Montgomery  
County Council

AGENDA ITEM #8A

## SUBJECT

Council worksession to discuss the recommendations of the Planning, Housing, and Economic Development (PHED) Committee regarding the Planning Board Draft of the Forest Glen/Montgomery Hills Sector Plan.

**EXHIBIT 2**

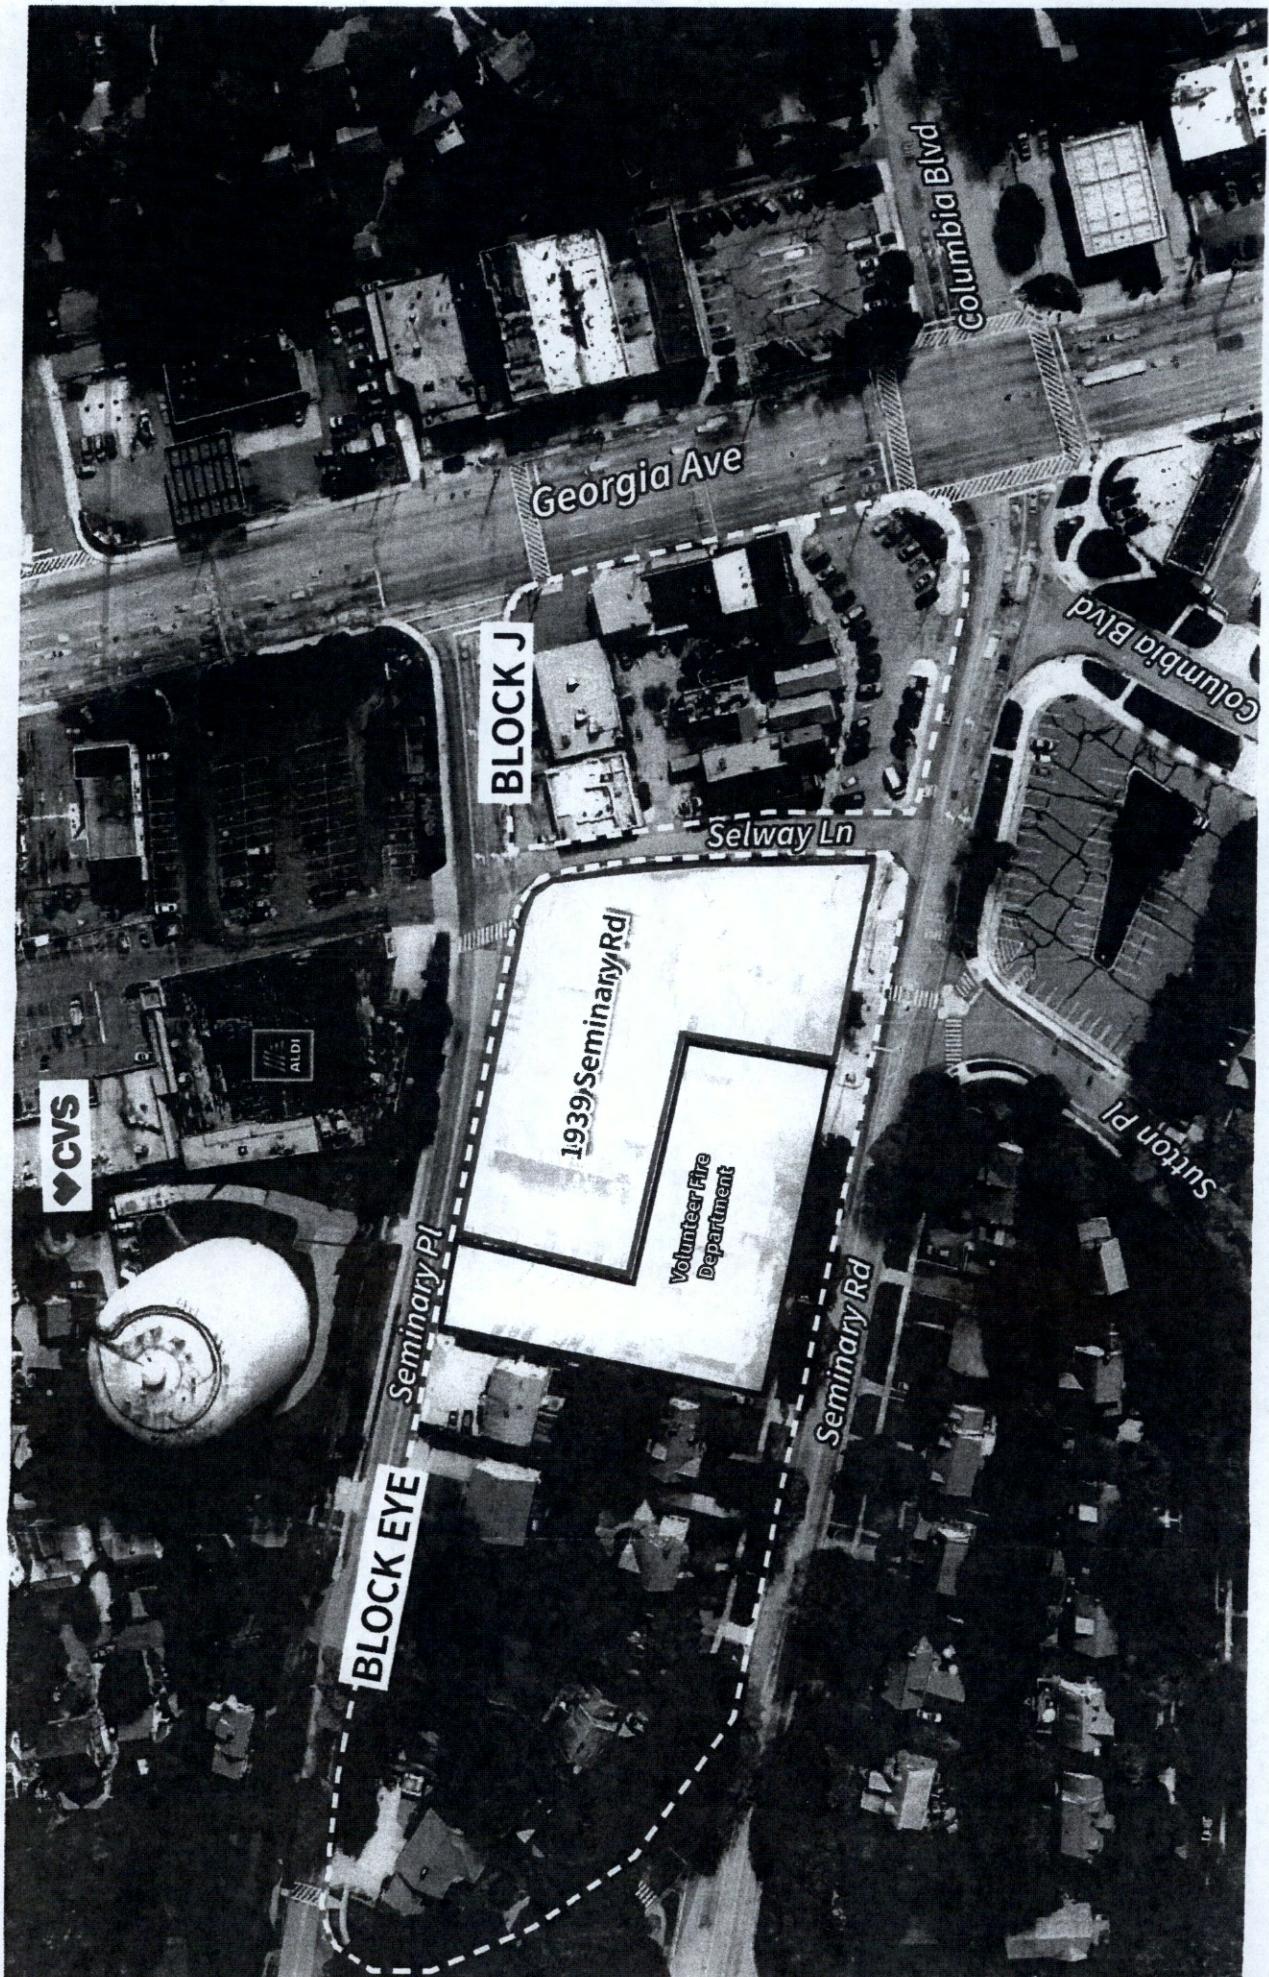
The Plan currently proposes a rezoning of the Snider's parcel from CRT-0.75, C-0.75, R-0.25, H-45 to CRT-1.5, C-1.5, R-1.5, H-60. See enclosed Exhibit 2, which illustrates the existing zoning and proposed zoning changes for Forest Glen and Montgomery Hills. The stated purpose of the Plan is to incentivize redevelopment and provide a through street. The Plan proposes a similar rezoning for Silver Spring Fire Station 19 (the "SS Fire Station" or "Station 19")—in the case of the SS Fire Station, from R-60 to CRT-1.5, C-1.5, R-1.5 and H-60. While we appreciate the proposed FAR increase for Snider's, given the competitive industry in which we operate and other reasons noted below, we request that the Council consider increasing the overall FAR for the Snider's parcel from the proposed CRT-1.5 to CRT-2.25. In this regard, I note:

**Committee Recommendation:** Support changing the zoning recommended for Sniders Super Foods to CRT-2.25 C-2.25 R-2.25 H-60. After a lengthy discussion regarding potentially increasing the height from 60 feet to 75 feet, the Committee agreed to retain the Sector Plan proposed height of 60 feet. The Committee agreed that language regarding the significant public benefit to the community of retaining a local grocery store at this site be added to the Plan.
